**SUBJECT****Seat Heaters Too Hot or Too Cold****MODEL**

Cooper, Cooper S

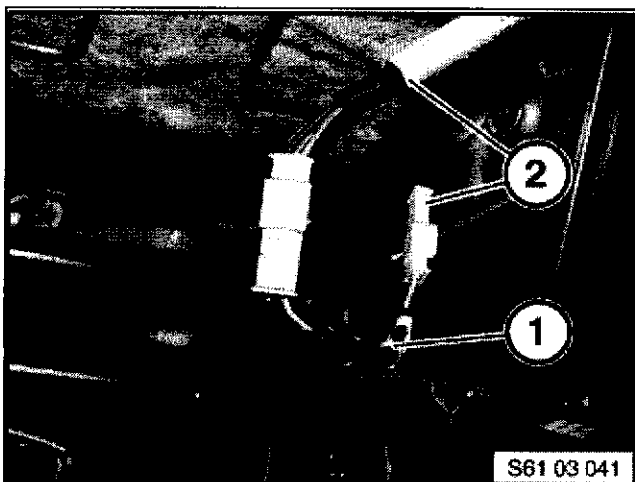
Locate and disconnect the white connector for the seat heater (1).

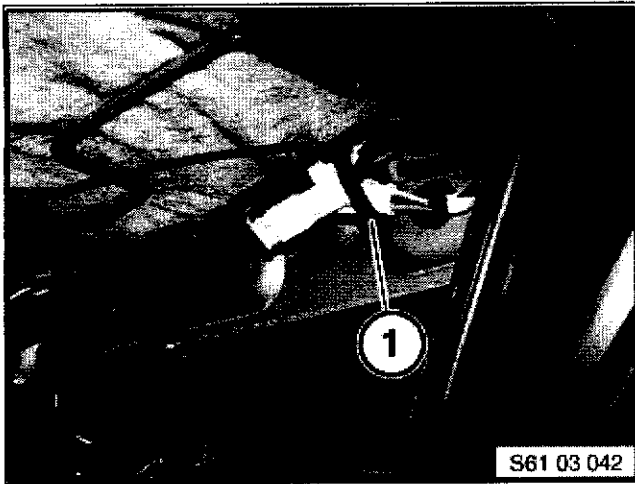
Install adapter cable (1) into existing harness (2).

Loop the additional length of the harness and wire tie (1) it in place.
